PIC18F66K80 Family Silicon Errata and Data Sheet Clarification

The PIC18F66K80 family devices that you have received conform functionally to the current Device Data Sheet (DS39977F), except for the anomalies described in this document.

Data Sheet Clarifications

FIGURE 11-2: USING THE OPEN-DRAIN OUTPUT (USARTx SHOWN AS EXAMPLE)

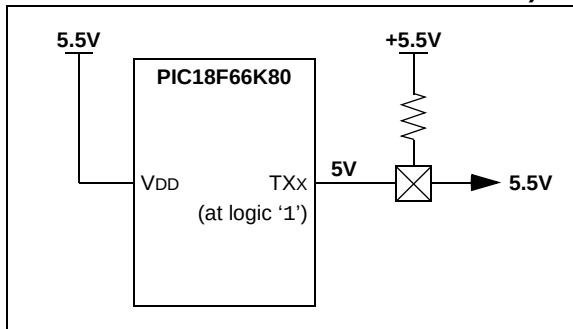
4.2 Open-Drain Outputs Diagram

[Figure 11-2: Using the Open-Drain Output \(Usart Shown as Example\)](#) on page 173 should be as follows:

Page 173 **Section 11.1.3 'Open-Drain Outputs'** will be revised to:

The output pins for several peripherals are also equipped with a configurable, open-drain output option. **This allows the peripherals to communicate with external pull-up voltage.**

The open-drain option is implemented on port pins specifically associated with the data and clock outputs of the USARTs, the MSSP module (in SPI mode) and the CCP modules. This option is selectively enabled by setting the open-drain control bits in the ODCON register.

When the open-drain option is required, the output pin must also be tied through an external pull-up resistor provided by the user.
